EB-PowerLite L570U/L770U/L775U

Firmware Release Note

3/25/2026

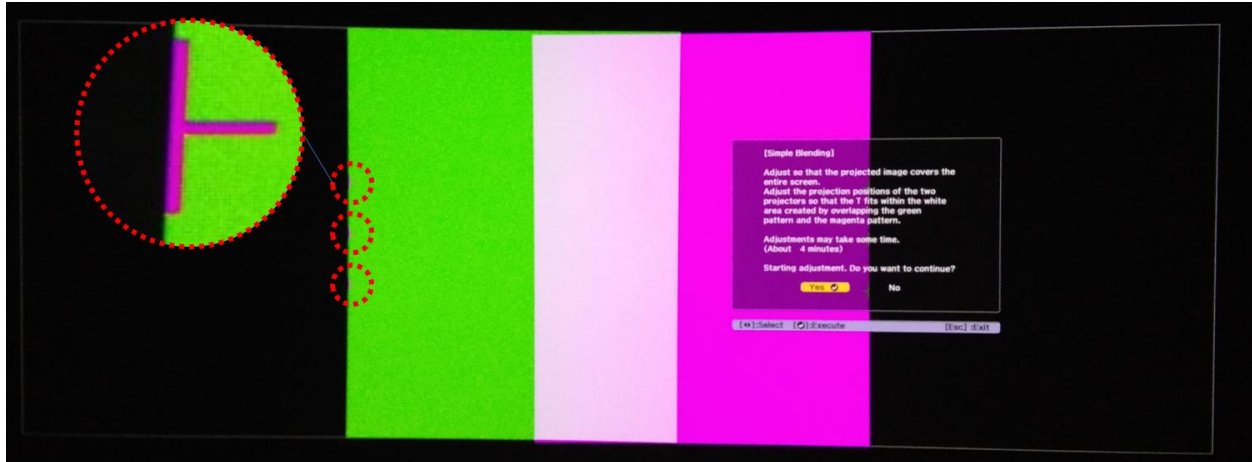
- 1) Max grouping units' quantity increases from 8 to 14 by using web control.
 - 2) The adjusted pattern of "Simple blending" was changed.
- Addition of T-mark as a guide for adjustment. (refer below red circle)

- The explanation dialog for adjustment was changed as below.

Adjust the projection positions of the two projectors so that the T fits within the white area created by overlapping the green pattern and the magenta pattern.
